DRESDEN NUCLEAR POWER STATION UNITS 2 AND 3

REQUEST FOR ADDITIONAL INFORMATION

REVIEW OF PROPOSED CHANGE TO TECHNICAL SPECIFICATIONS TO DELETE

REQUIREMENTS FOR JET PUMP FLOW INDICATION

Figure C.10-4. Jet Pump Flow Distribution Calibration No. 11, October 17, 1971

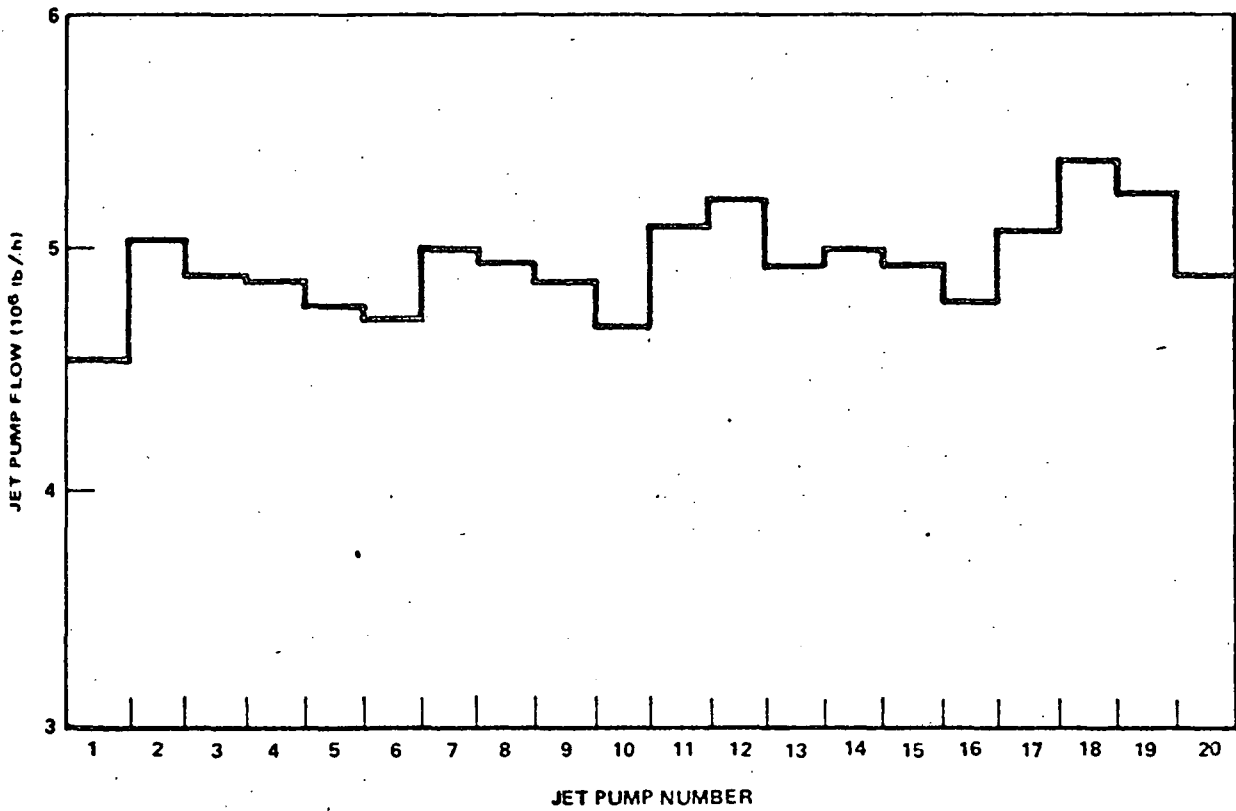
5. Provide the latest flow readings (at ~ 100% power) of all jet pumps for all stations. Provide data in same format as figure C.10-4 on C-93/C-94 of NEDC-10692 (Startup Test Results, Dresden Nuclear Power Station Unit 3, January 1, 1971 - November 16, 1971) and include actual value recorded. A copy of figure C.10-4 is enclosed. This data will be utilized in the analysis of jet pump performance at other stations.
